ADDENDUM #2

Date:	03.05.2014	Addendum No:	2
Project:	York General Health Care Services Hospital Addition And Remodel	Project No:	24902
To:	Jake Kulhanek	Firm:	Sampson

1 FLOOR PLAN LEVEL 1 - POWER - AREA "C"
E2-3 3/16" = 1'-0"

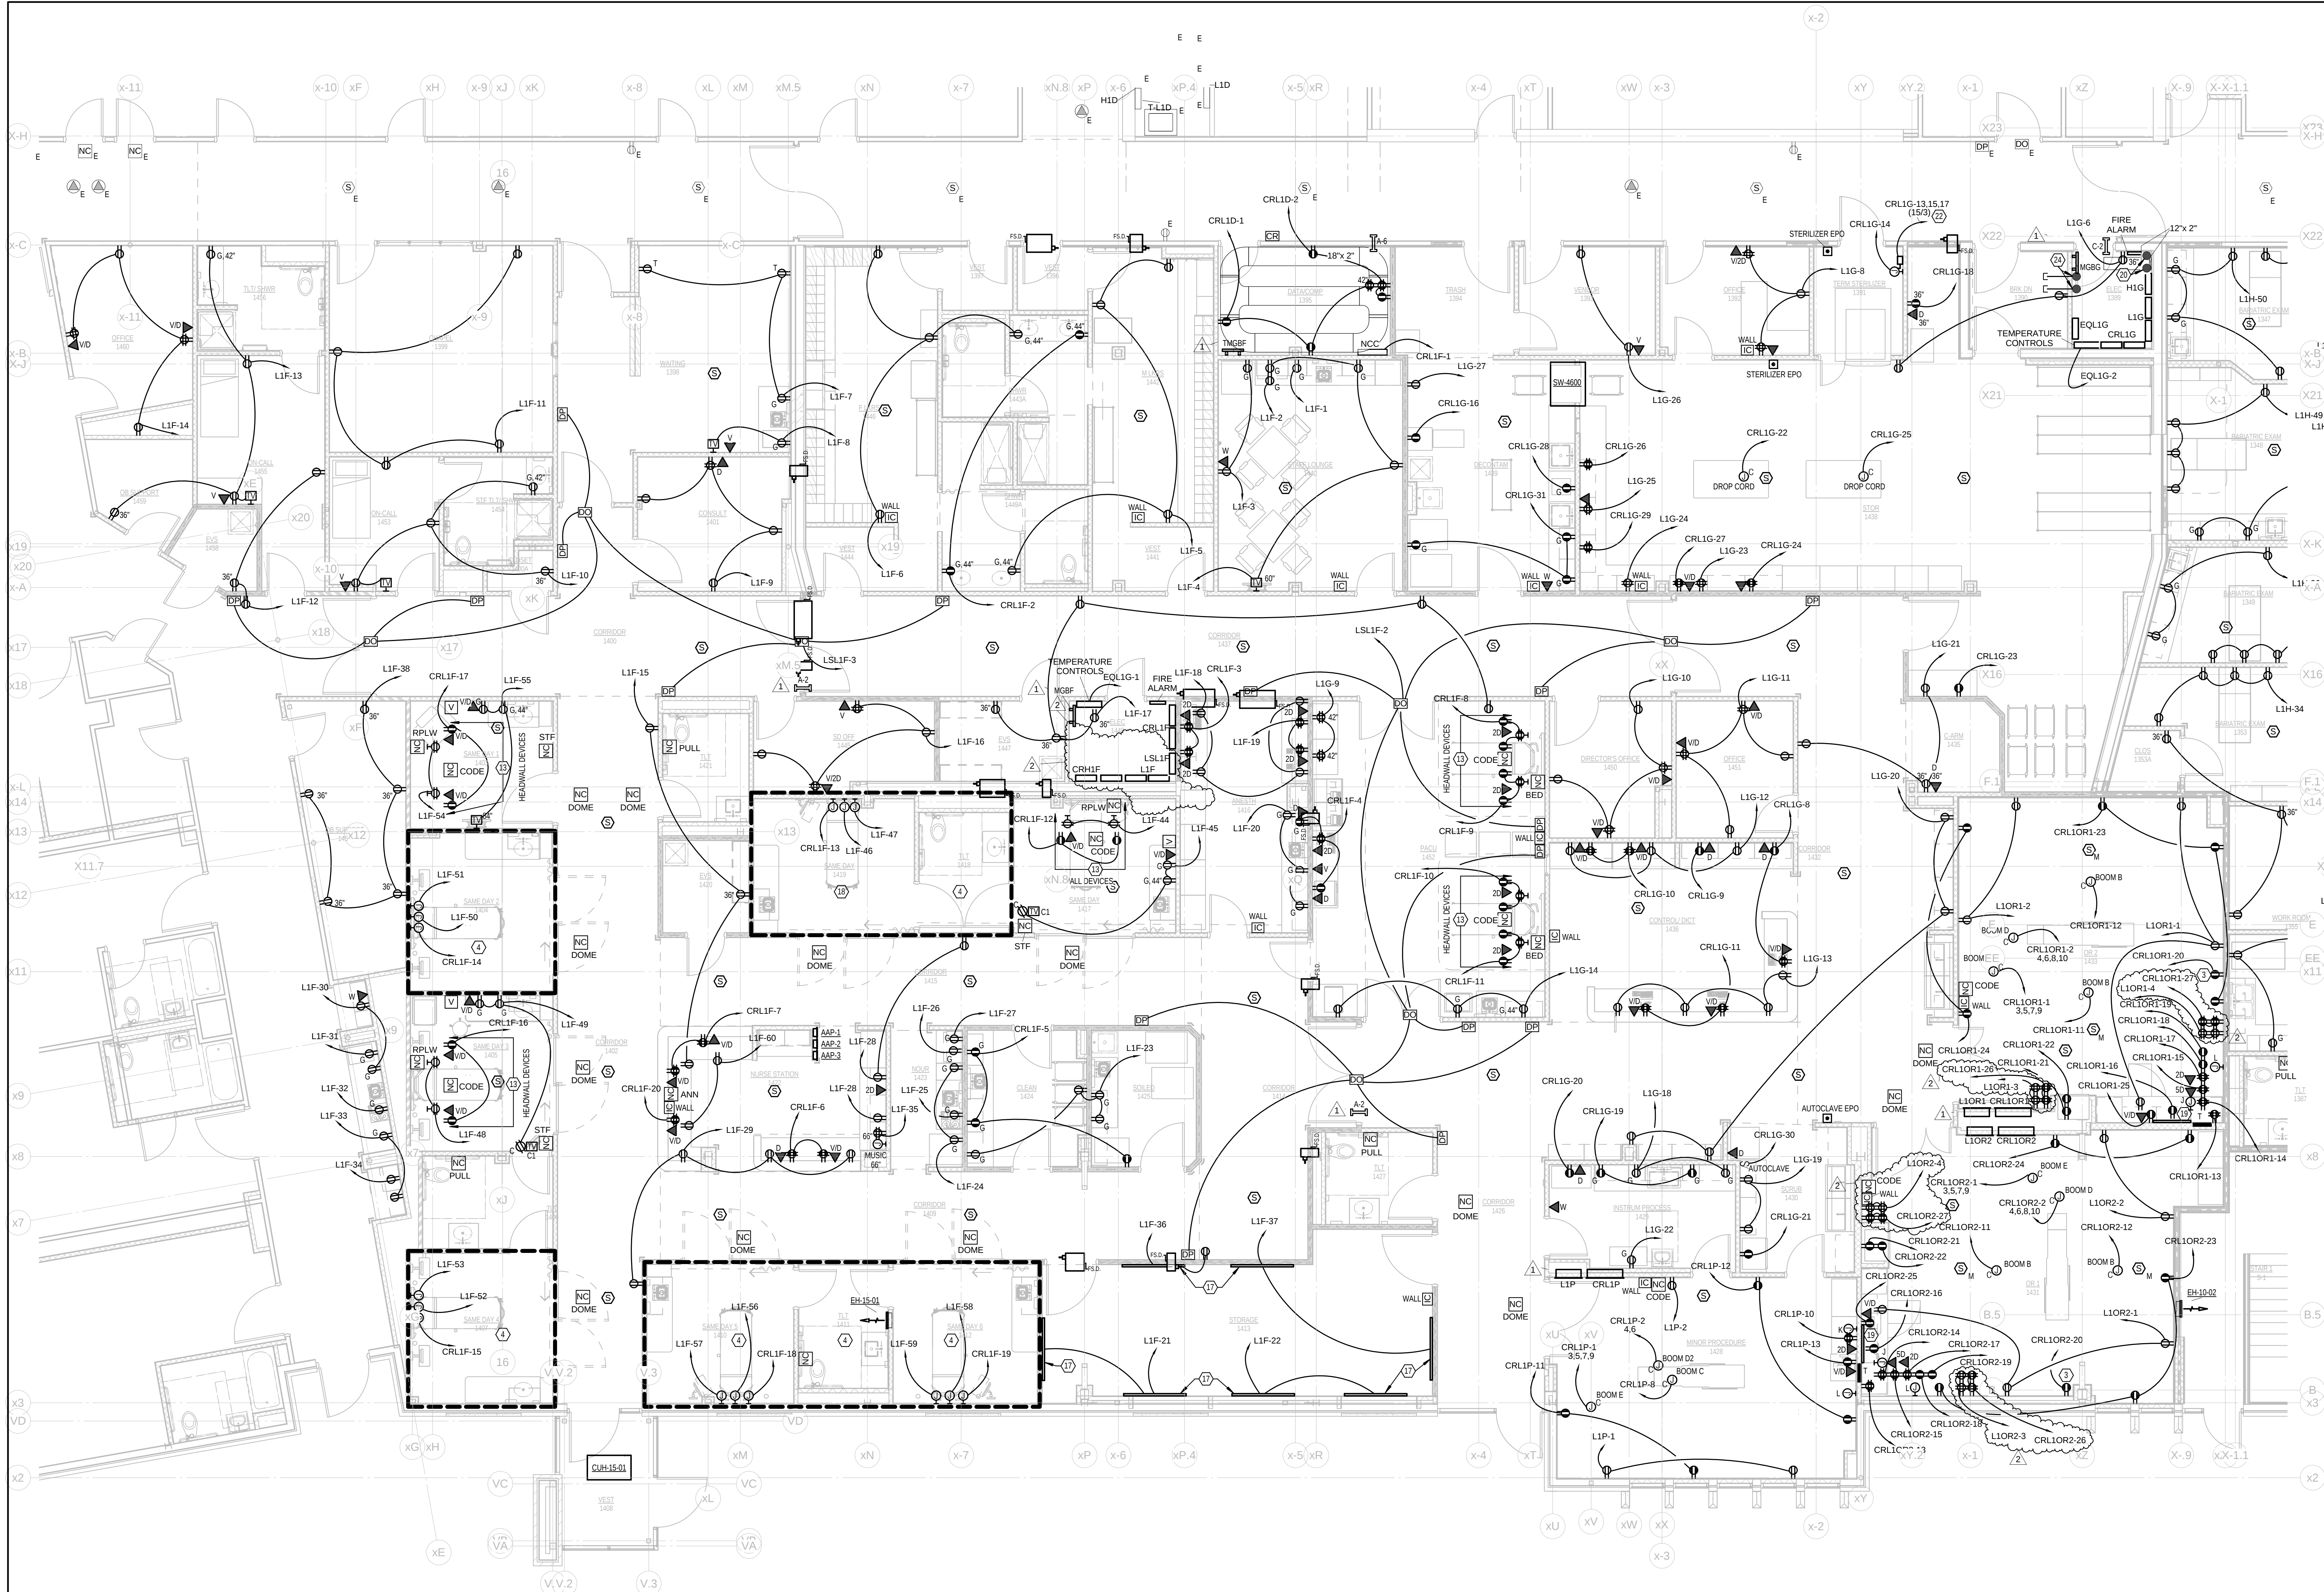
- A. E1-3 – Floor Plan – Lighting – Area C
- B. E2-3 – Floor Plan – Power – Area C
- C. E4-1 – Electrical One-Line Diagram
- D. E5-1 – Electrical Panel Schedules
